**WESTINGHOUSE DOCUMENT LTR-RCPL-06-6, RESPONSE TO NRC REQUEST
FOR ADDITIONAL INFORMATION ON PALISADES RELIEF REQUEST TO USE
METHODOLOGY OF WCAP-15973-P-A, REV. 0, "LOW ALLOY STEEL COMPONENT
CORROSION ANALYSIS SUPPORTING SMALL-DIAMETER ALLOY 600/690 NOZZLE
REPAIR/REPLACEMENT PROGRAMS," DATED JANUARY 19, 2006
(NON-PROPRIETARY)**

**Response to NRC Request for Additional Information on
Palisades Relief Request to use Methodology of WCAP-15973-
P-A, Rev. 0, "Low Alloy Steel Component Corrosion Analysis
Supporting Small-Diameter Alloy 600/690 Nozzle
Repair/Replacement Programs"**

January 19, 2006

Figure 1: Palisades Pressurizer Heater Sleeve

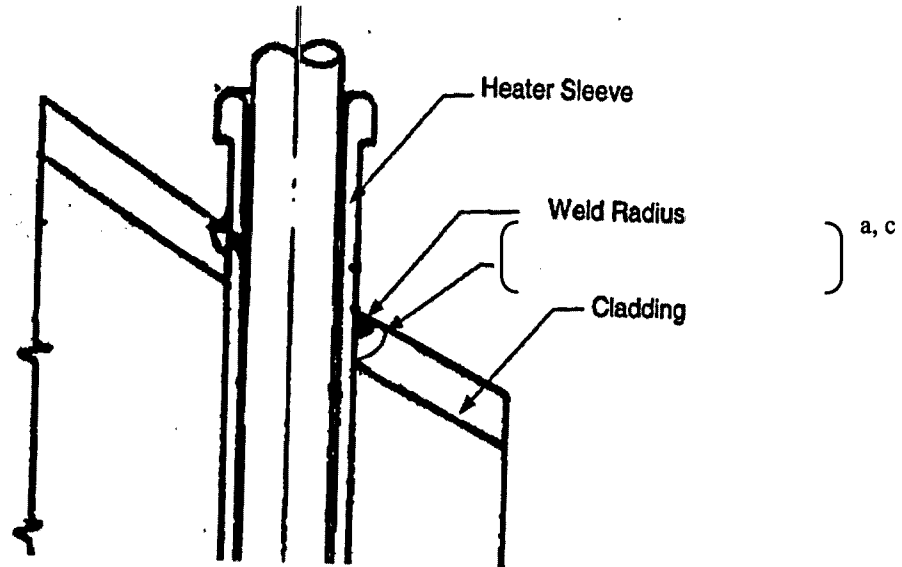
RAI 4.2 — Provide the linear elastic fracture mechanics (LEFM) analysis, and include an evaluation of the available Charpy impact test data to demonstrate the reference temperature (RT_{NDT}) used in the LEFM is limiting for all Palisades nozzle penetrations included in this relief request.

The methodology and results of the WOG topical report and its supporting calculation (References 1 and 2) are generically applicable to the Combustion Engineering NSSS design. Representative geometry, transients, and material properties for fracture toughness were assumed. In support of the NMC relief request (Reference 7) and using the generic WOG methodology, Westinghouse performed a Palisades-specific crack growth evaluation applicable to the pressurizer heater sleeve locations and transients. A summary of the results from the LEFM (linear elastic fracture mechanics) analysis and from the evaluation of the Charpy impact test data (Reference 4) is given below. The detailed LEFM evaluation is included in Appendix A.

By comparing the final crack sizes listed in Table 3 with those of Table 1, it can be seen that the total crack growth for the Palisades geometry and transient conditions are relatively low and compare favorably to their allowable crack sizes. From Table 4, at the end of the 500 heatup and cooldown cycles and after 220°F insurges, there remains significant margin to the allowable crack tip stress intensity factor (SIF). As an illustration of how little the postulated flaws grow, Figure 3 compares flaw depth growth in the direction along the borehole and along vessel inner diameter as a function of heatup and cooldown transient cycles.

In summary, the total flaw growth is relatively small and there is adequate margin relative to the final flaw sizes. The detailed evaluation is provided separately in Appendix A of this document because of its Mathcad format.
